August 23, 2001

SUBJECT: TECHNICAL ASSISTANCE REQUEST - REVIEW OF GROUNDWATER
TEST RESULTS SUBMITTED BY VIRGINIA POWER CO. FOR ITS
CATEGORY I SERVICE WATER POND DAM AT NORTH ANNA

Project: Dam Safety Inspection - North Anna Category I Service Water Pond Geochemistry

FIGURE 1
PLAN-CURRENT INSTRUMENTATION
SERVICE WATER RESERVOIR
NORTH ANNA POWER STATION

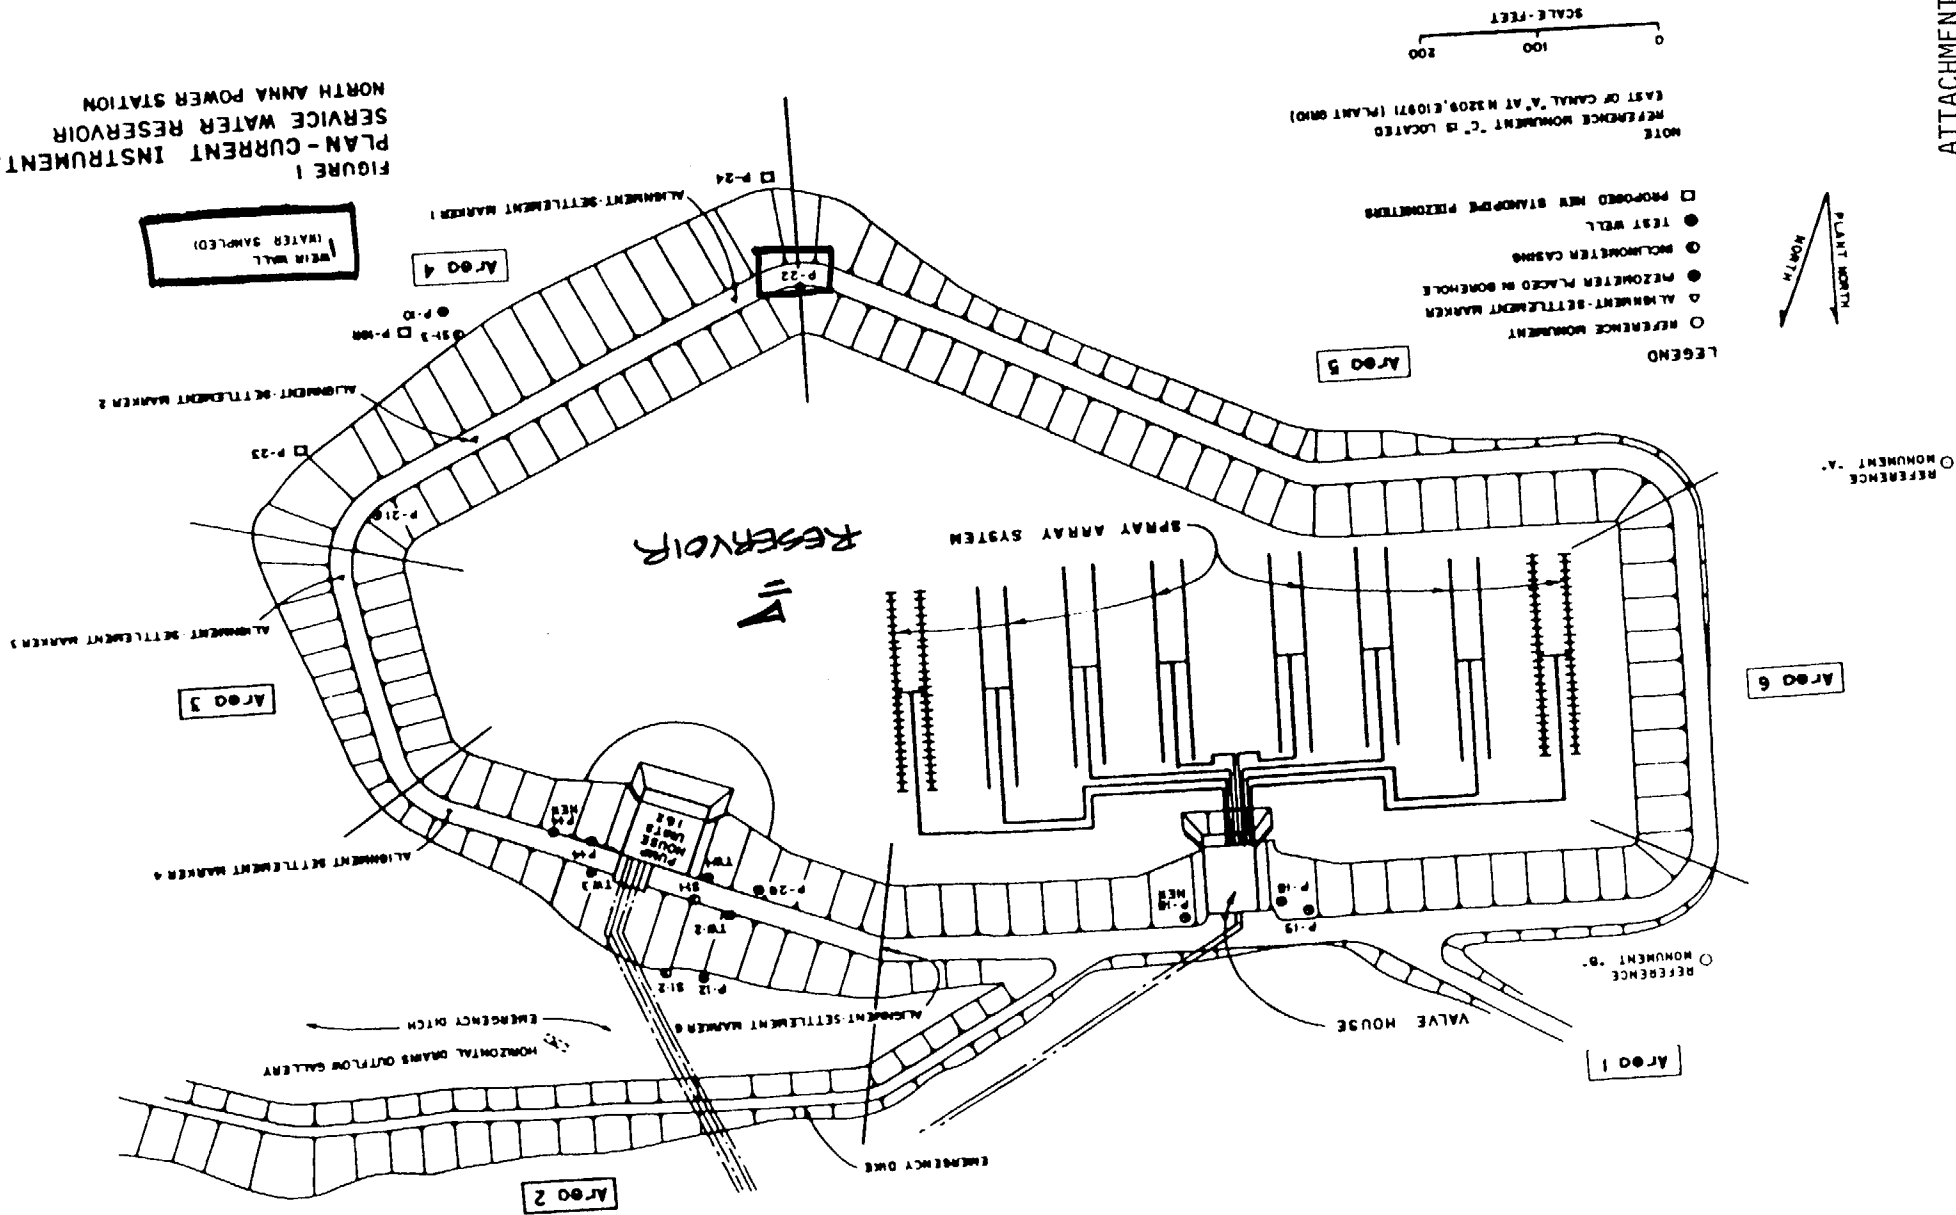
Requested Action: Reviewer shall determine if information submitted by Virginia Power Co. (VPC) is sufficient to determine if impounded water can be related chemically to water from piezometer P-22 and/or surface water from a wet area below the SWR dike. If licensee-provided information is insufficient, reviewer shall provide written recommendations for appropriate testing to make such determination. If the information provided is sufficient, then reviewer shall make a written opinion regarding any relationship of the water from the three sources.

Background: In 1997, 1999, and 2001, NRC has observed apparent seepage water below the SWR embankment. VPC has stated that the water is runoff, unrelated to seepage. On January 12, 1998, VPC took water samples from the SWR, piezometer P-22, and ponded water below the SWR dike. VPC ran conductivity tests and concluded that the water from P-22 and below the SWR dike did not originate from the reservoir. A technical review of the test results and conclusions is requested.

4. Virginia Power Corporate staff indicated that analysis of seepage water could determine whether seepage was from the SWR. Once the weirs are operational, water samples should be taken to see if the water source is in fact the SWR.

Action: Water samples were taken from three areas around the SWR on January 12, 1998 to measure conductivity. These included water from the service water reservoir, water from piezometer P-22 casing during bailing, and ponded water at the weir wall in the wet area below the SWR dike and adjacent roadway (Attachment 2, Figure 1).

Piezometer P-22	99 micromhos
Weir Wall	123 micromhos
Service Water Reservoir	922 micromhos

Conductivity is a measure of a solution's capacity to conduct electric current and depends on the presence of ions. The more dissolved salts/ions that are present in the solution the higher the conductivity that would be expected. The substantially higher conductivity values obtained from the SWR sample is due to the biocidal and other chemical treatment used in the reservoir.

These conductivity tests clearly indicate the water obtained from piezometer P-22 and the drainage area did not originate from the reservoir and therefore are not the result of seepage from the reservoir. As a comparison, the conductivity of distilled (de-ionized) water ranges from 0.05 to 2.0 micromhos.

Action: Results of the conductivity tests on a water sample taken from the weir wall which is located downstream or downgradient from the other weirs, clearly indicates that the water did not emanate from the reservoir. Therefore, reactivating weir flow measurements would only measure runoff and groundwater movement which would provide extraneous data not pertaining to SWR seepage or stability. In our opinion, such effort is unwarranted.
